Request for Additional Information No. 473(5531), Question 06.02.05-24

U. S. EPR Standard Design Certification

SRP Section: 06.02.05 - Combustible Gas Control in Containment

Question 06.02.05-24:**OPEN ITEM****Follow-up to RAI 372, Question 06.02.05-15**

Figure 6.2.5-15—Global AICC Temperature and Dome Temperature from a Realistic Burn

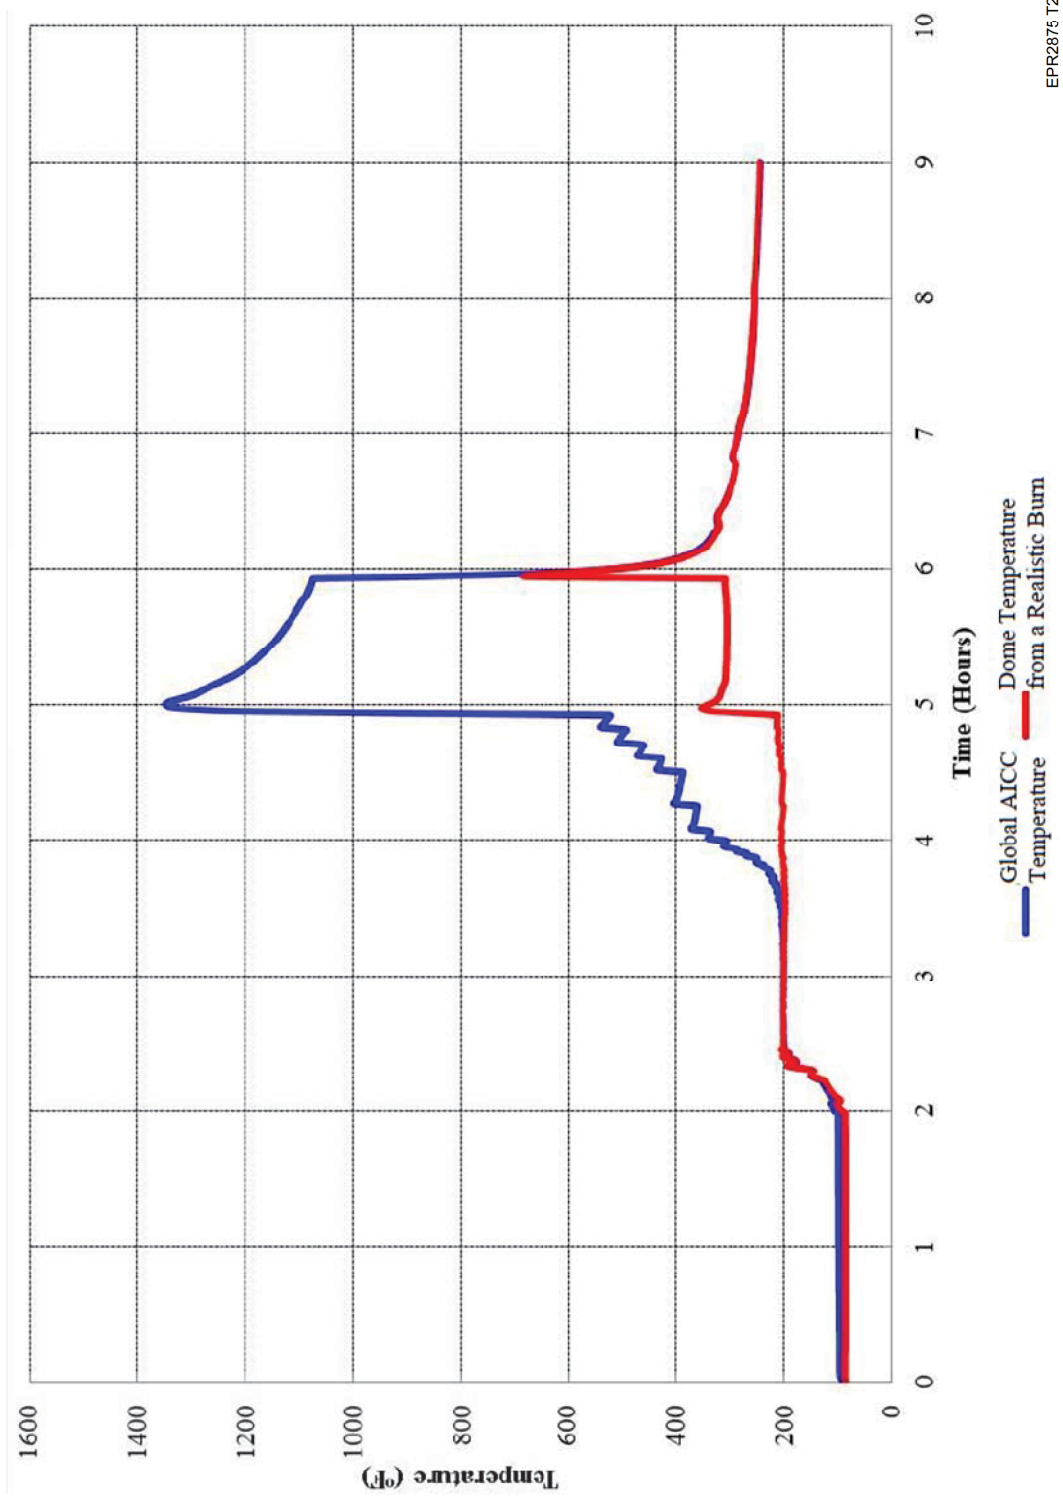
- a. provide a justification, item by item, that the equipment identified above as requiring a survivability assessment is sufficiently similar to the equipment tested by EPRI in 1985, and;
- b. to provide the temperature and pressure vs. time throughout the containment during a hydrogen burn in an amount equivalent to that generated from a fuel clad-coolant reaction involving 100% of the fuel cladding. Provide a description of the scenario modeled, and address whether or not the PARs were credited as functioning.

Part (b) of Question 06.02.05-24 refers to the equivalence of the EPRI burn conditions with those of the U.S. EPR containment temperature and pressure vs. time during a hydrogen burn.

The containment dome temperature and global AICC temperature are presented in a new U.S. EPR FSAR Tier 2, Figure 6.2.5-15—Global AICC Temperature and Dome Temperature from a Realistic Burn.

- The AICC pressure and temperatures are theoretical values only that cannot be reached because actual combustion is not adiabatic, isochoric, or complete. U.S. EPR FSAR Tier 2, Figure 6.2.5-15 depicts containment dome temperature of about 700°F, which is a realistic hydrogen burn temperature, whereas the AICC temperature of around 1350°F is a theoretical value.
- A hydrogen combustion load is relatively brief (on the order of seconds) and does not result in a significant increase in equipment temperature.

U.S. EPR FSAR Tier 2, Section 6.2.5.3.2 will be revised, and a new Figure 6.2.5-15 added, as described in the response and indicated on the enclosed markup.

Figure 6.2.5-15 shows the containment dome temperature from a realistic hydrogen burn and the global ACC temperature. Note that AICC pressure and temperatures are theoretical values that cannot be reached because actual combustions are not adiabatic, isochoric or complete.
